**NOTICE OF A REGULAR MEETING
BONDURANT PLANNING AND ZONING COMMISSION
MARCH 24, 2022**

Item No. 6.b.
For Meeting of 3/24/2022
Resolution

TITLE: - RESOLUTION NO. PZ-220324-09: Considering recommended approval of the Edgeland Bondurant Preliminary Plat and Site Plan at Outlot R of the Quail Run Phase 2 Preliminary Plat development area.

TITLE: - RESOLUTION NO. PZ-220324-10: Considering recommended approval of the 1001 23rd Street SW Site Plan

[illegible]

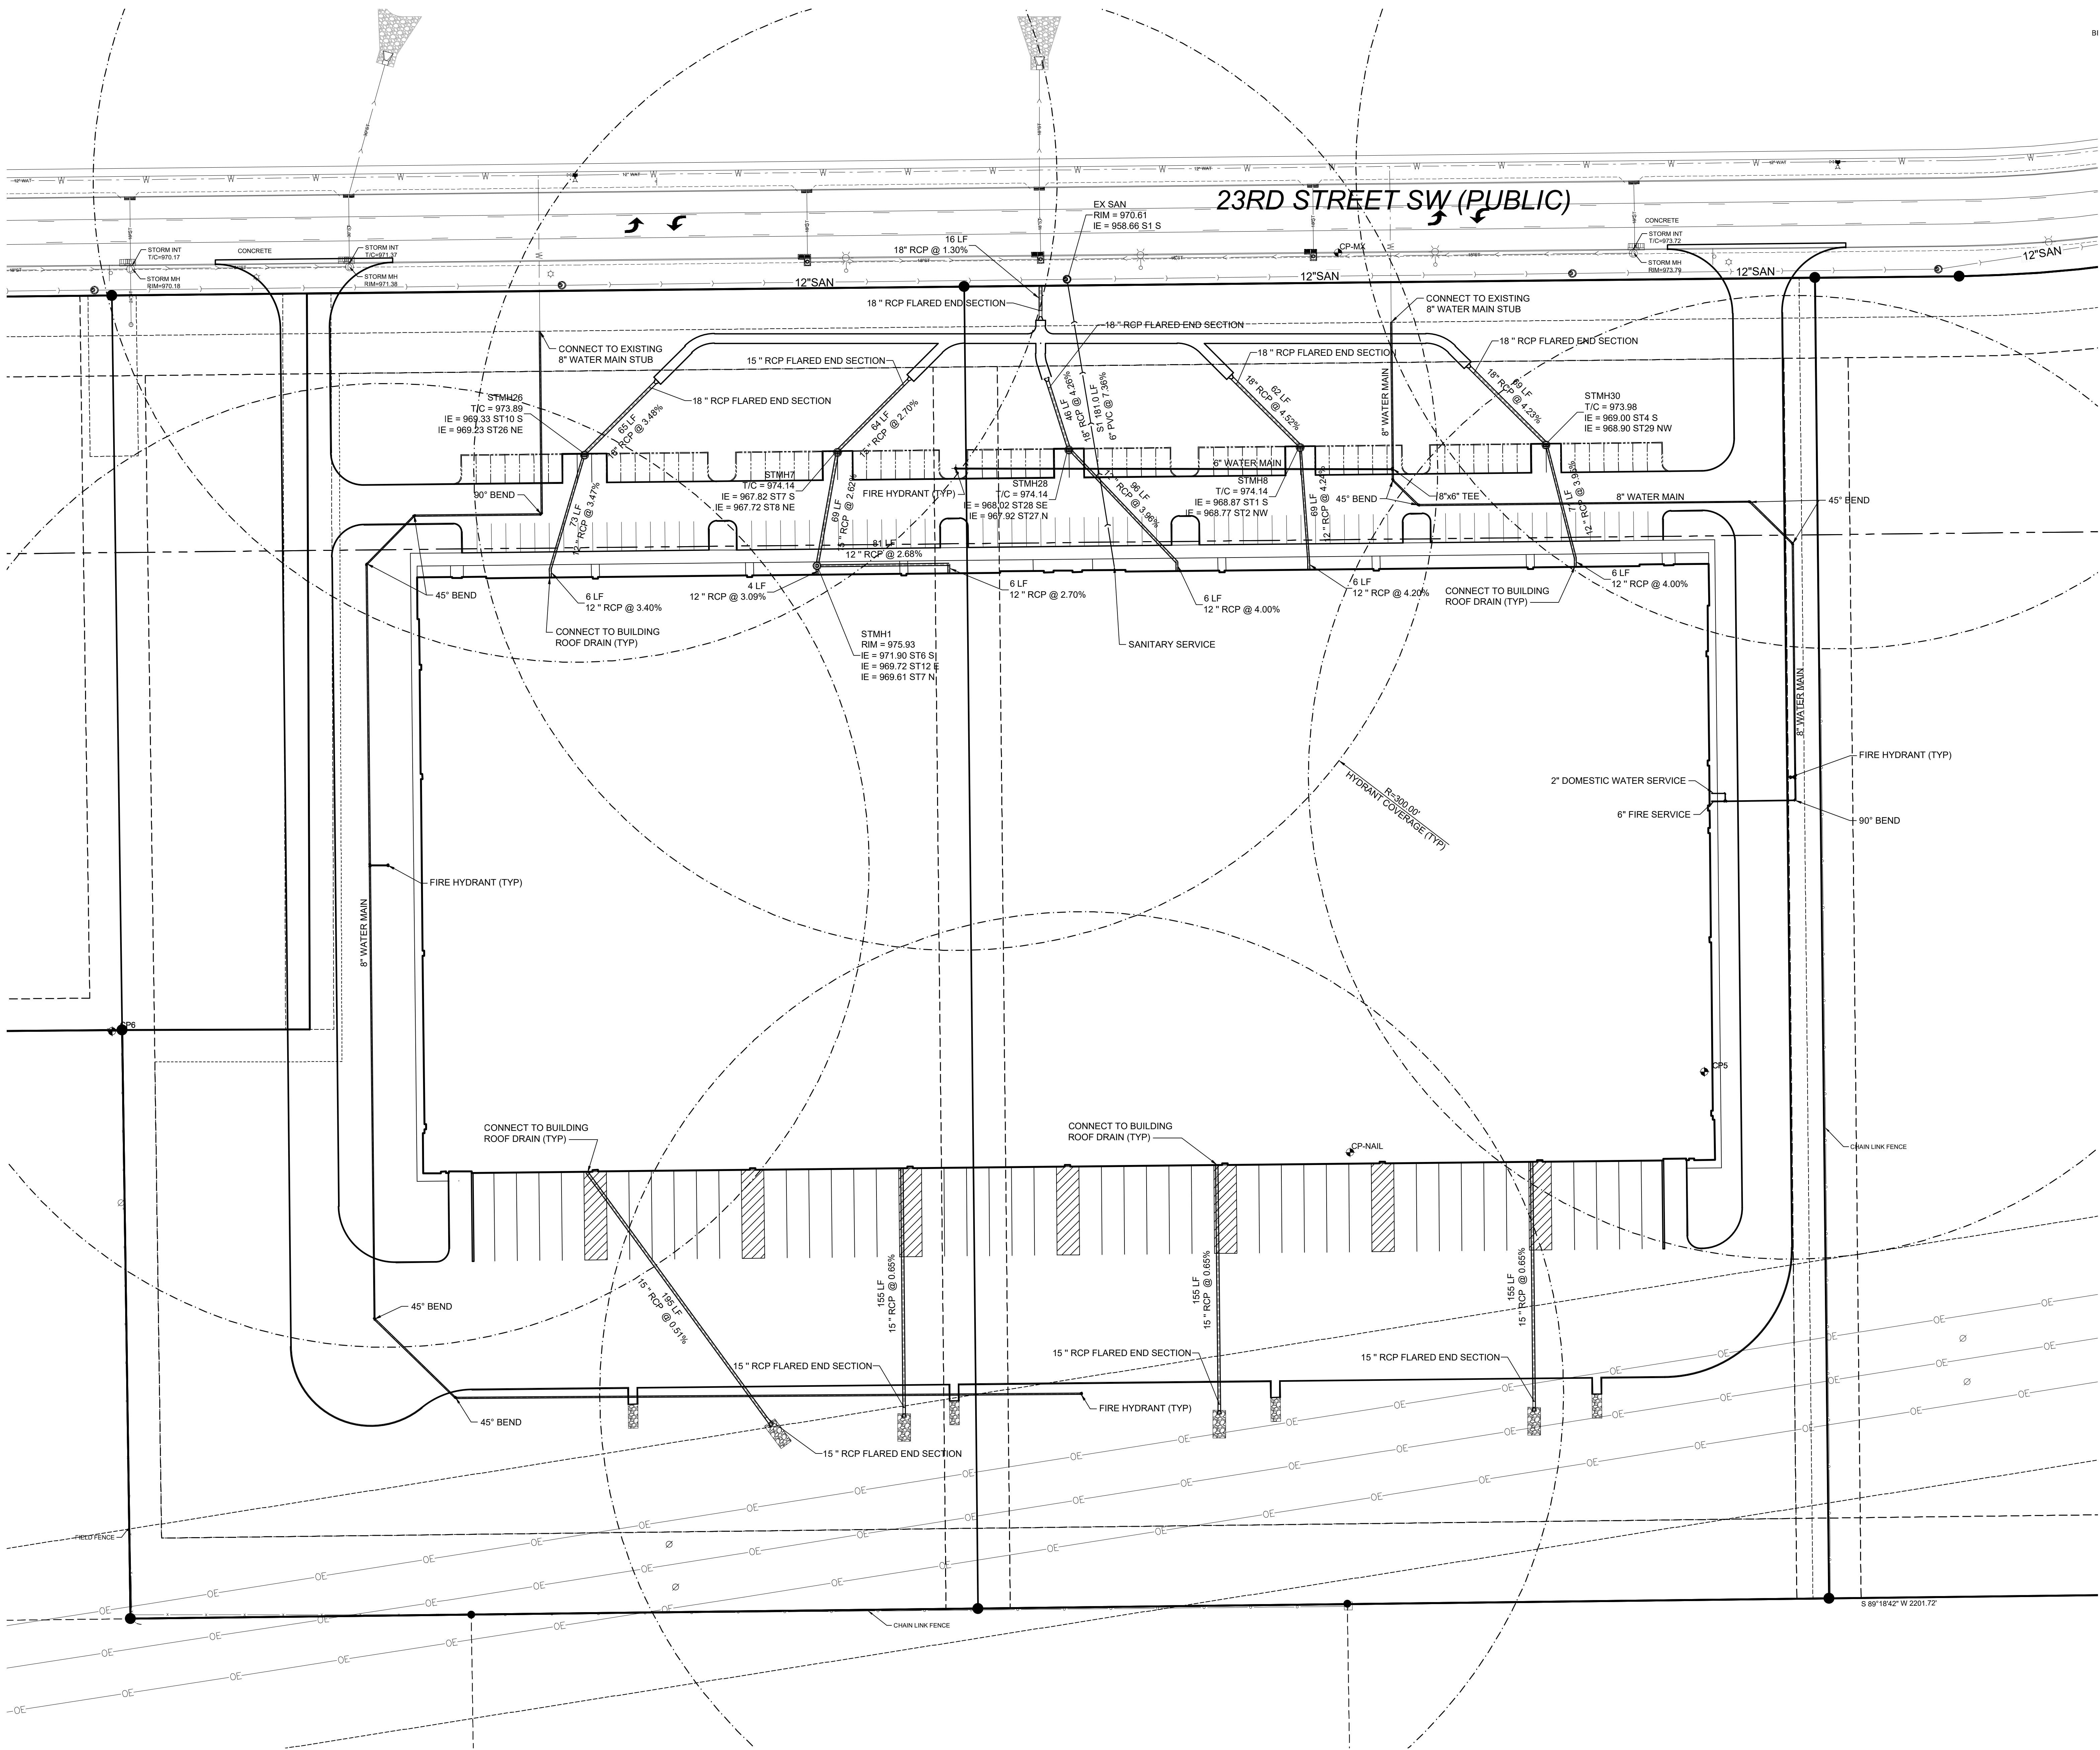
Section 177.09.21 of the Zoning Code requires at least one parking space on the lot per be provided each employee at one time. Currently, 72 parking stalls are proposed, however, the site plan is currently lacking on the number of employees; the attached P&Z recommendation resolution takes this into account.

As currently proposed, a total of 3 handicapped spaces are required for the site. The site plan notes that 5 ADA parking stalls are proposed, however, the locations of these five stalls are not proposed. This has been factored in as part of the attached resolution.

The site plan shows it, but does not label the existing sanitary sewer easement that exists along the north property line.

The plat of survey being considered in Item 6.d shows a 30'x100' access easement at the west driveway. The site plan will need to be updated to show this easement area.

2. That the site plan's employee count information be completed to ensure minimum parking stall count requirements will be met.
3. That approval of this site plan also includes approval of the future potential parking space areas as shown on the plan. If this future parking space area is constructed, the developer must provide updated total impervious surface calculations to the City for stormwater billing purposes.

4. That the site plan be updated to clarify the number and location of the ADA parking spaces proposed.
5. That the landscaping plan be updated to show that at least 21 general trees will be planted within the required minimum front yard setback area.

6. That the site plan be updated to show/label all existing and proposed easements on site.
7. That sidewalks may be required if/when the City determines a logical connection exists, as is allowed per Chapter 136 of the City Code.

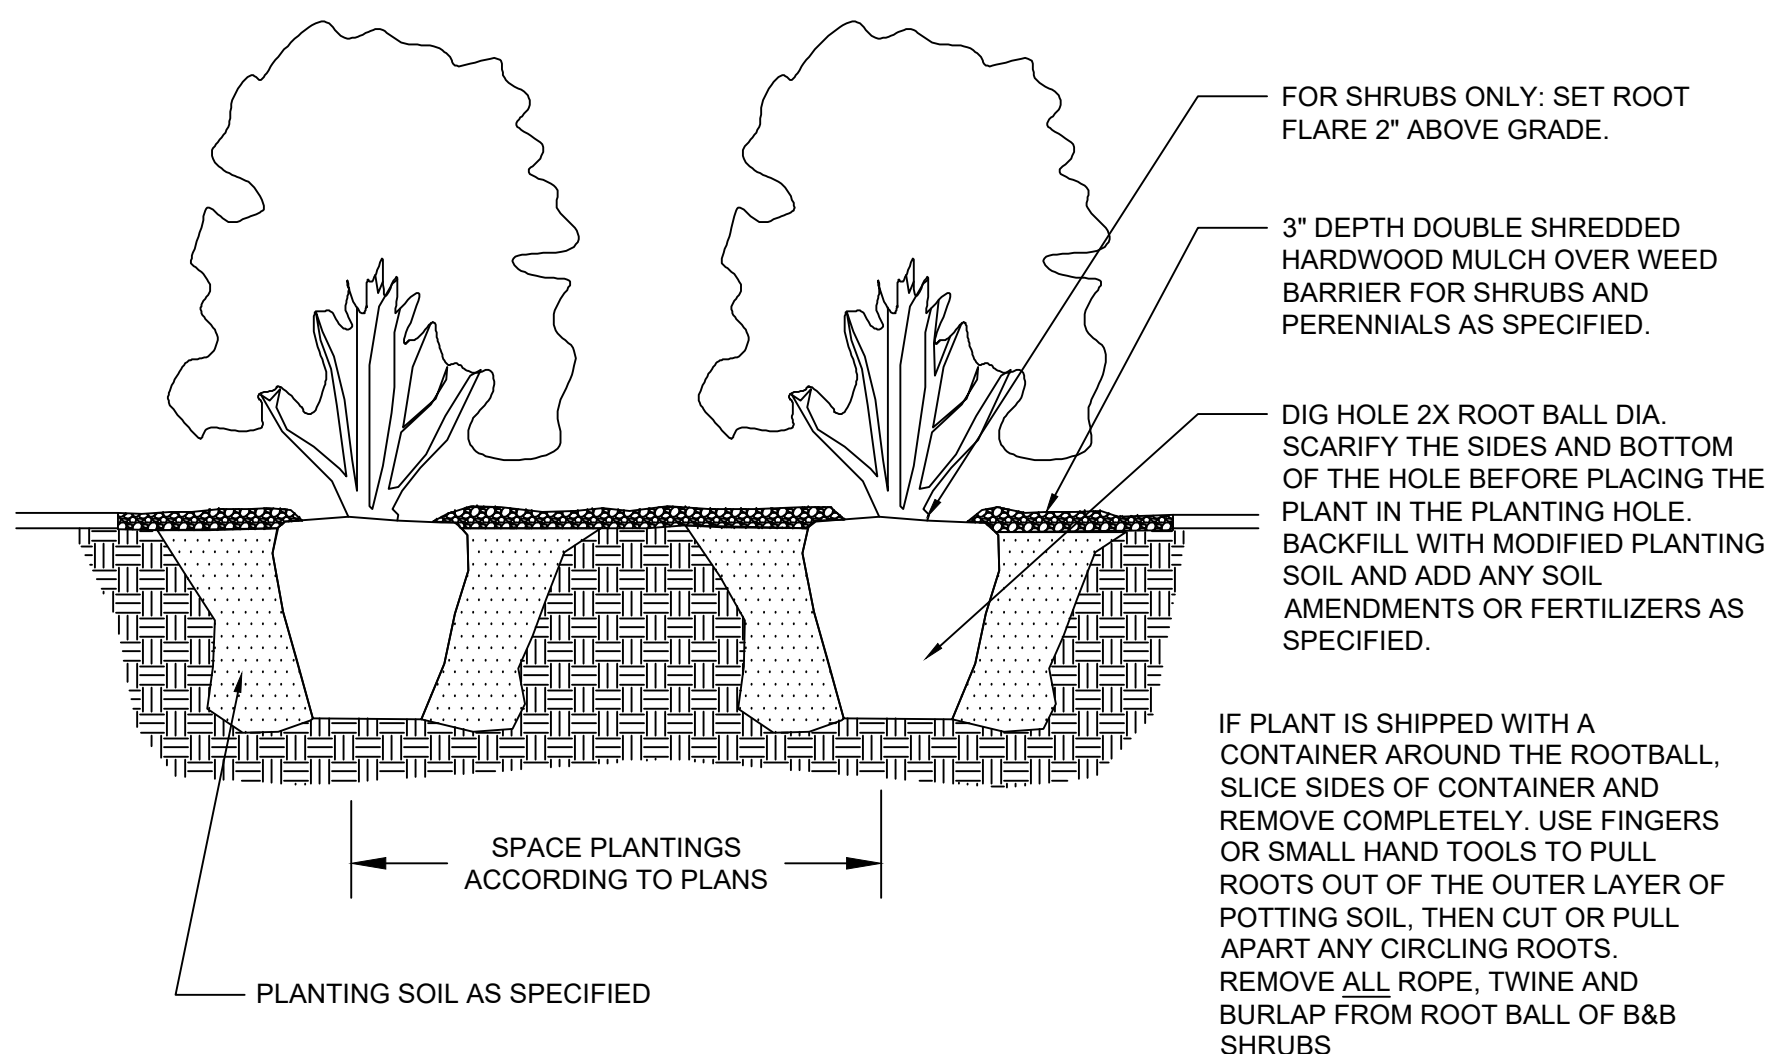
General trees/greenspace: the site has a total of 1,061 feet of frontage, requiring 21 plantings in the required front yard area; the submitted landscaping plan does not currently meet this minimum front yard tree planting requirement - this has been factored in as part of the attached resolution. A minimum open space requirement of 15% is required in the M-1 district; 38.1% of open space is shown on the site plan, exceeding the City's requirement. The landscaping plan shows the minimum tree size planting requirements (1 3/4" caliper for deciduous and 5' minimum for coniferous) will be met with this project.
